County of Ventura
Board of Supervisors Hearing
September 15, 2020
Case No. PL17-0141

**Final EIR, Chapter 2, Organization Comments and Responses
to Comments**

2.5 ORGANIZATIONS

Revised Figure 4.12-1 Oil and Gas Well 2,500 foot Setback from Schools

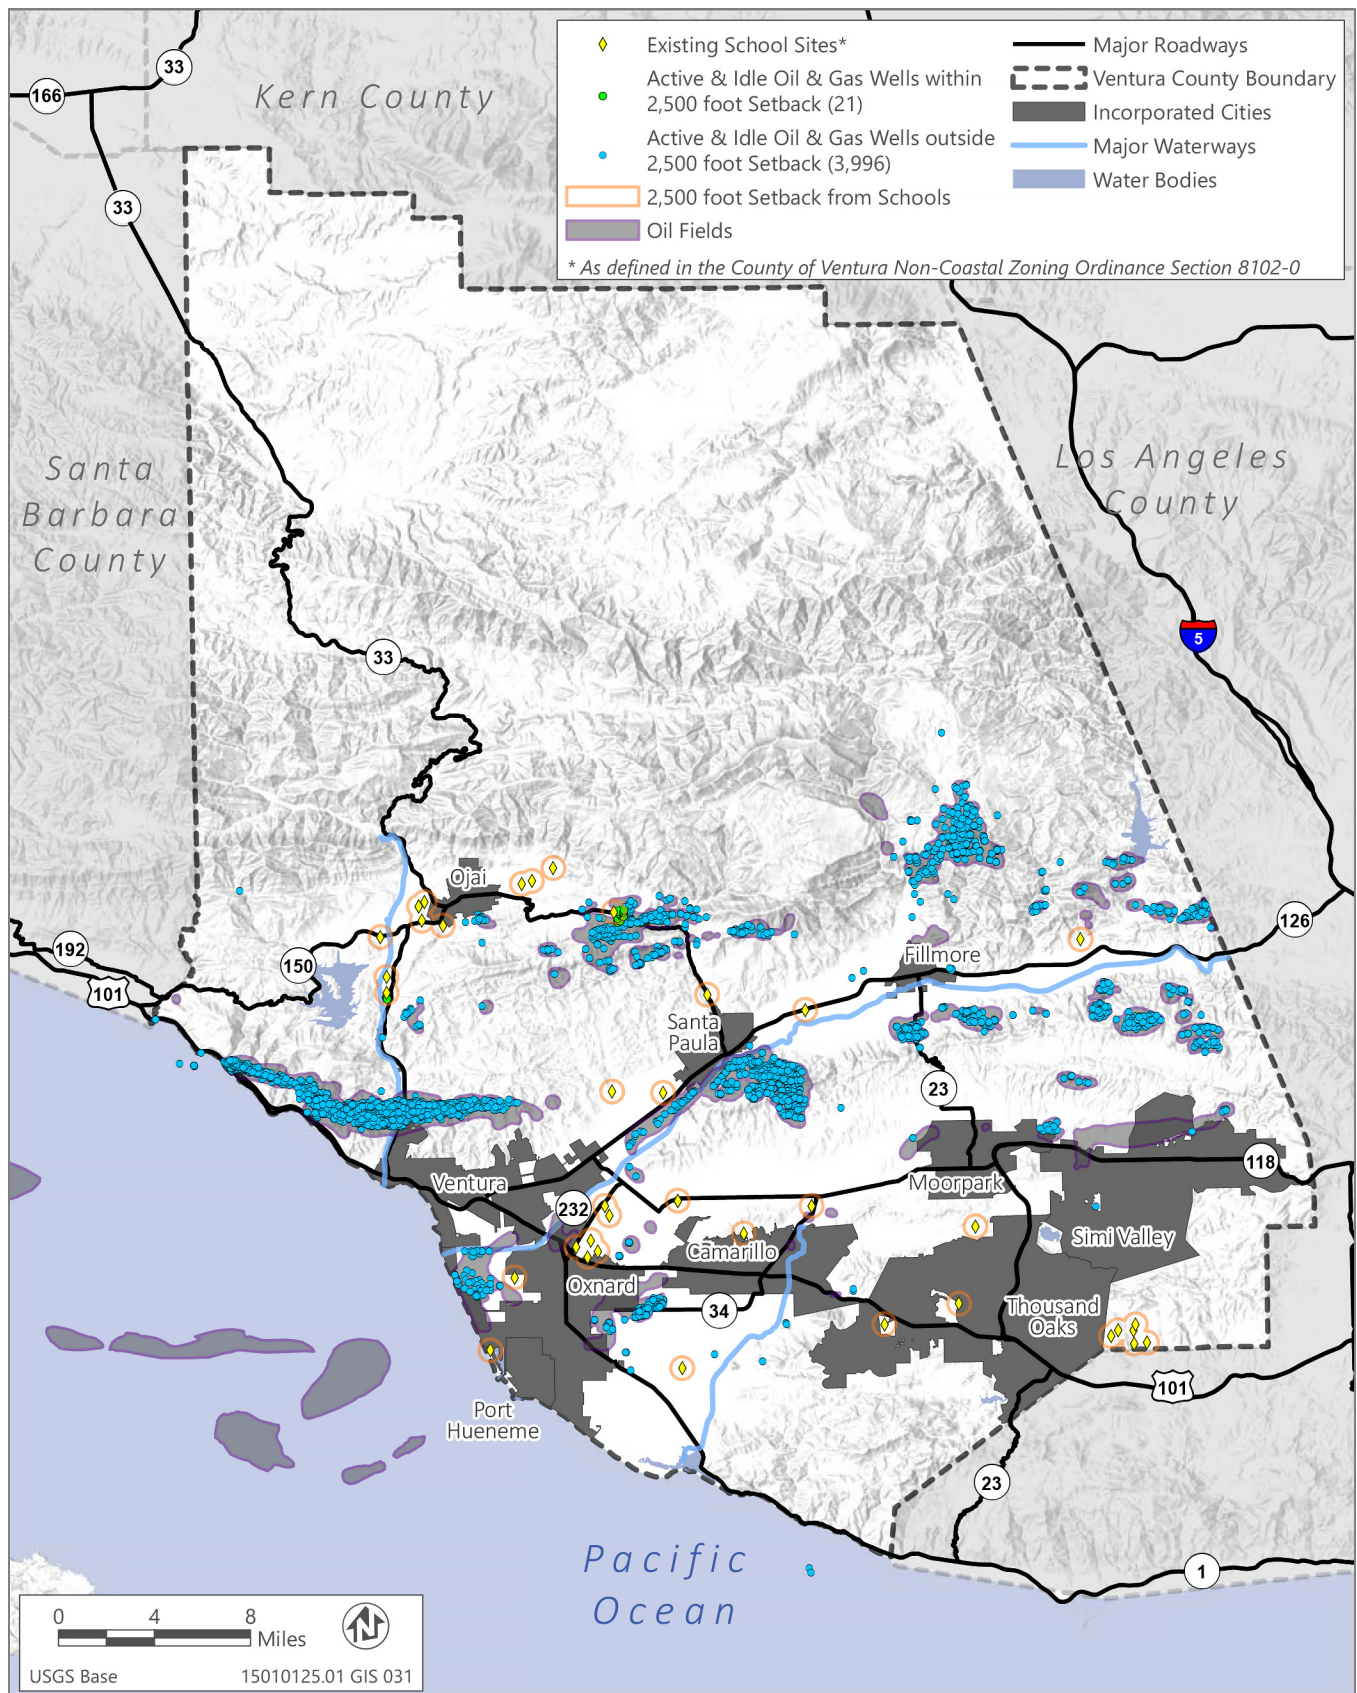
4.12 Mineral and Petroleum Resources	4.12.2 Environmental Impacts and Mitigation Measures Figure 4.12-1 & 4.12-2	4.12-15 4.12-16	The scale of the maps identified in Figure 4.12-1 and 4.12-2 make it difficult to see the scope of wells affected by the setback requirements. Multiple maps should be included in this section displaying a more accurate scale so that the maps are useful to the public to properly see	O15-23

the scale of impact. Additionally, a table should be provided identifying the number of wells affected by this policy.	
4.12 Mineral and Petroleum Resources	4.12.2 Environmental Impacts and Mitigation Measures Figure 4.12-1	4.12-15 4.12-18	Subparagraph titled "Significance after Mitigation" on page 4.12-18 states, "NCZO defines schools as educational facilities for pre-college levels of instruction; specifically limited to elementary, middle school and high schools offering full curricula as required by State Law." Colleges, such as Thomas Aquinas College, do not meet this definition but are identified in the map provided in Figure 4.12-1. These Colleges should be removed from the analysis of the maps as they do not apply to this definition of a school.	O15-23 cont.

O15-23 Refer to Master Response MR-4, Section MR-4.H, “Buffers (Setback),” Section MR-4.E, “Applicability of Reference Studies for Oil and Gas Operations,” and Section MR-4.G, “Pipeline Requirements,” regarding the findings and conclusions related to setbacks, and the adequacy of the reports used to derive the findings and conclusions. Additionally, the commenter notes that Thomas Aquinas College, which does not meet the definition of a school pursuant to Policy COS 7.2, is incorrectly identified in the draft EIR Figure 4.12-1, Oil and Gas Well 2,500-ft Setback from Schools Map (page 4.12-5). Figure 4.12-1 includes the following notation in the legend “As defined in the County of Ventura Non-Coastal Zoning Ordinance Section 8102.” The draft EIR indicates that the Ventura County Non-Coastal Zoning Ordinance (Section 8102-0 defines schools as educational facilities for pre-college levels of instruction; specifically limited to elementary, middle school and high schools offering full curricula as required by State law. The Ventura County Coastal Zoning Ordinance does not include a definition for schools (page 4.12-18). The commenter is correct that Thomas Aquinas College was incorrectly depicted on Figure 4.12-1. Furthermore, the legend on Figure 4.12-1 did not include the full citation for the Section 8102-0 of the Non-Coastal Zoning Ordinance. Figure 4.12-1 has been revised in response to this comment, as shown below.

As a result of the figure revisions made in response to this comment, the last sentence of the second paragraph on page 4.12-14 in Section 4.12, “Mineral and Petroleum Resources,” is revised as follows:

As shown in Figures 4.12-1 and 4.12-2, there are currently 21 ~~23~~ active and idle oil wells within 2,500 feet of existing schools and 715 active and idle oil wells within 1,500 feet of existing dwelling units in the unincorporated county.
